30 October 2015

**Re: New Berrima Clay/Shale Quarry (PA08_0212 MOD1)
Response to DPI - Water's Groundwater Concerns**

Figure 11: Bowral Quarry – Mittagong Rivulet Diversion Channel
(Source: Response to Submissions – Page 38)

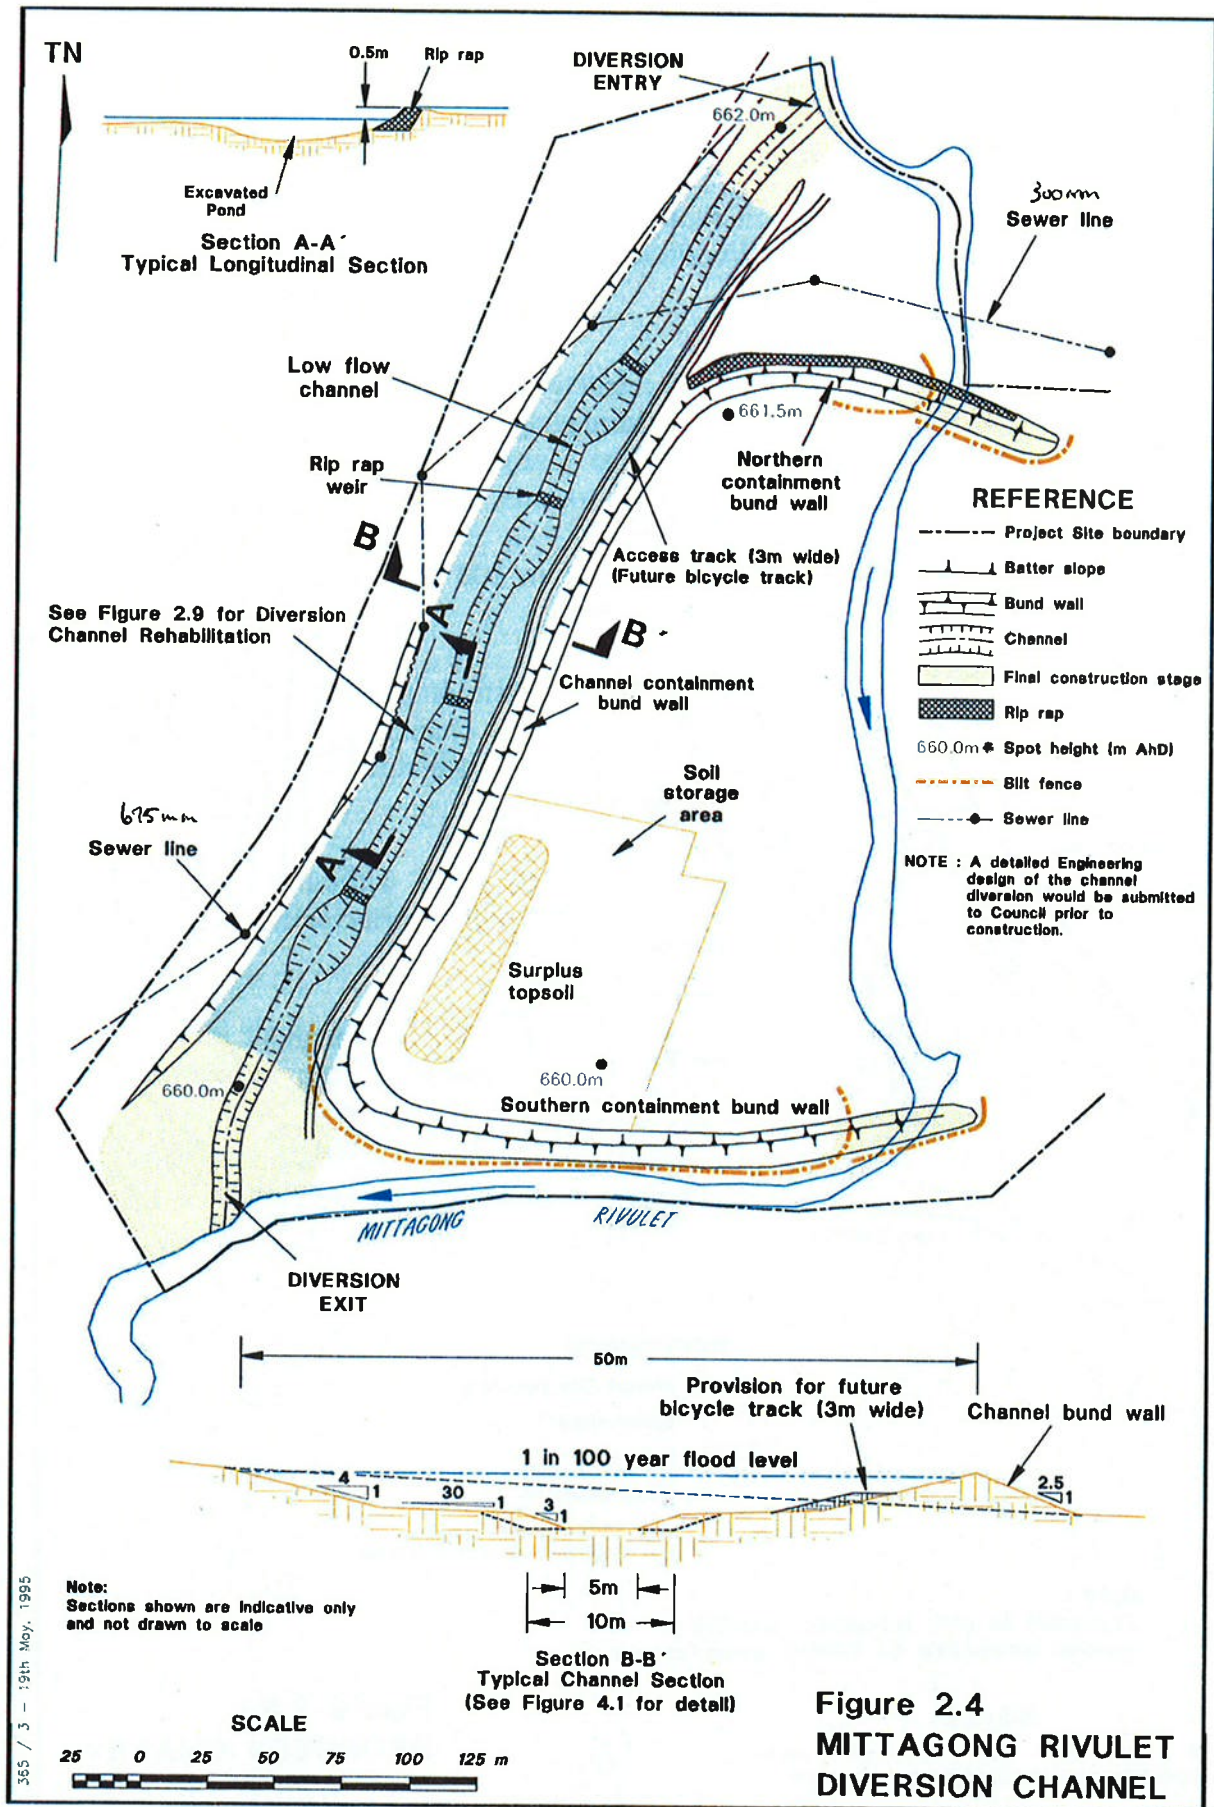
As outlined in the Response to Submissions (Section 2.8), Austral's experience at its Bowral Quarry adjacent to the Bowral Brick Plant has provided an excellent understanding of the potential for groundwater intersections and perched water levels within the Ashfield Shale, particularly in close proximity to a substantial watercourse. The western boundary of the Bowral Quarry is approximately 25m from the centre of the Mittagong Rivulet (a watercourse with a catchment above the Quarry of 22km²). The Mittagong Rivulet is a tributary of the Wingecarribee River. The attached **Figure 11** from the Response to Submissions (1995 EIS Figure 2.4) and **Figure 12** from the Response to Submissions (1995 EIS Figure 2.6) display the proximity of the existing Bowral Quarry to the Mittagong Rivulet.

The hydrogeological characteristics of the Ashfield Shale are such that occasional localised and negligible (unmeasurable) inflows of water occur following rainfall. The negligible inflows are attributable to the considerable thickness (4m to 6m) of residual clay that typically lies above the unweathered shale, as is the case on the "Mandurama" property. These inflows are typically manifested as damp areas on the exposed extraction faces. It is also worth noting that no seepage of water occurs from the adjoining Mittagong Rivulet into the Bowral Clay/Shale Quarry despite the base of the Quarry being 30m to 40m below the base of the rivulet.

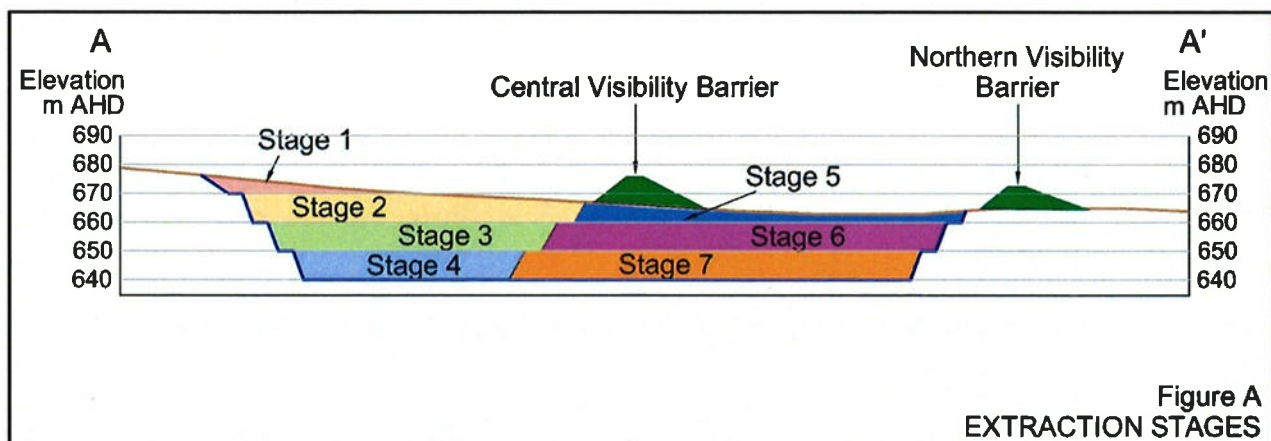
To support baseline data collection prior to groundwater interception, DPI - Water recommends the proposed monitoring bores be installed and monitoring commenced prior to commencement of extraction for Mod 1. ... [to] enable a better assessment of the ongoing project and its future should the nature of the surrounding district and its natural or modified environment change to any significant extent. The baseline information will also enable a better assessment in terms of the requirements of the NSW Aquifer Interference Policy.

Figure A provides a cross section through the extraction area showing the staged development of the Quarry. Extraction within Stage 1 (to 670m AHD) and the early parts of Stage 2 will effectively provide the materials required for the construction of the Central Visibility Barrier. It is likely that extraction in Stage 2 would continue for approximately three years after the construction of the Central Visibility Barrier before extraction reaches 660m AHD. Towards the end of Stage 2, piezometers would be installed and the Groundwater Management Plan component of the Water Management Plan would be prepared and submitted to DPE and DPI - Water.

This above approach is proposed as it is highly unlikely that the regional groundwater would be intercepted above 660m AHD based upon the height and topographical location of the extraction area and Austral's experience at the Bowral Quarry. It remains a very high probability that the regional groundwater table will not be intersected at all throughout the life of the Quarry.
